ROAD MAP FROM THE 1985 DRAFT TS TO PROPOSED DRAFT TS

**WATTS BAR TECHNICAL SPECIFICATION RETENTION AND
RELOCATION SUMMARY TABLE
(ROAD MAP)**

August 1992, Revision 0

Figure 2.1.1-1 (page 1 of 1)
Reactor Core Safety Limits

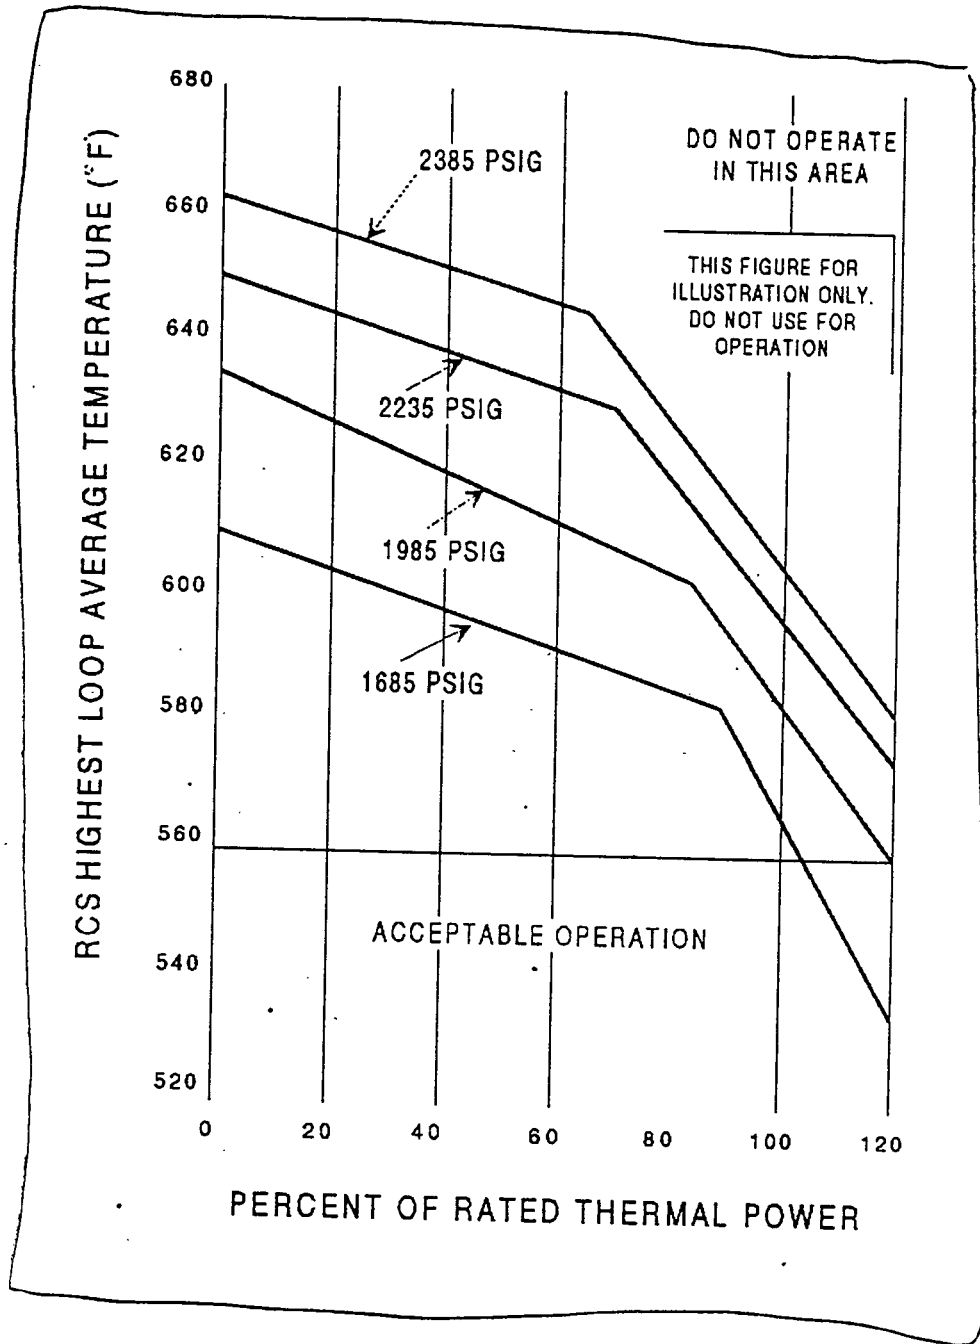
Replace with plant specific figure.

1. Change to reflect Watts Bar specific terminology.
2. Change to reflect Watts Bar specific parameter values.
3. Watts Bar prefers to use the expanded reference description in the Bases.
4. Change to correct error in the STS.
5. On Figure B 2.1.1-1, "OP DELTA T" and "OT DELTA T" are annotated in error. They should be indicated just the opposite.
6. In the Applicable Safety Analyses section, Item b. should read, "Steam Line PORVs." A steam line relief valve could mean a safety valve or PORV. A steam Line would better describe what is intended.

Figure 3.1.4-1 (page 1 of 1)
Moderator Temperature Coefficient vs. Power Level

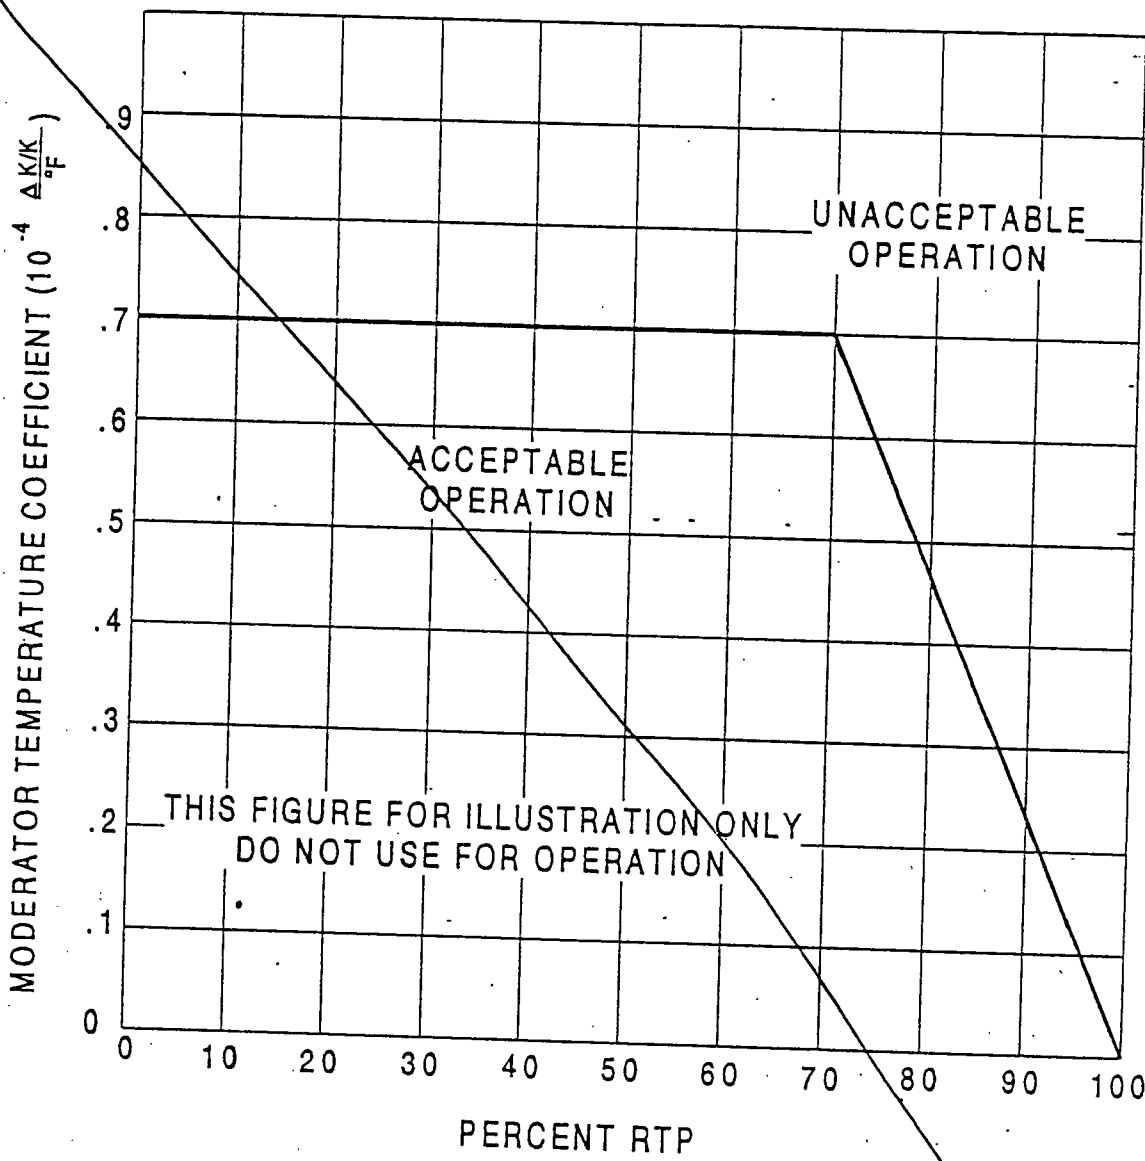
LCO 3.1.4 The MTC shall be maintained within the limits specified in the COLR. The maximum upper limit shall be $\leq 0.0 \Delta k/k^* F$ at hot zero power ~~[that specified in Figure 3.1.4-1]~~.
 (Handwritten annotations: ②, ③, ④, ①)

1. Change to correct typographical error in STS.
2. Format change to delete brackets that identify plant specific information/values.
3. Change to reflect WBN specific parameter value.
4. WBN utilizes the same maximum moderator temperature coefficient upper limit for all power levels. Therefore, Figure 3.1.4-1 is unnecessary.
5. Change to correct editorial error(s) in STS.
6. Change to specify WBN specific reference information and format.
7. This change reflects comments made by the industry to the NRC at the Proof and Review meeting on the RSTS in Irvine, CA July 13 - July 20, 1992.
8. Revised this statement since for MSLB events the core briefly returns to criticality.
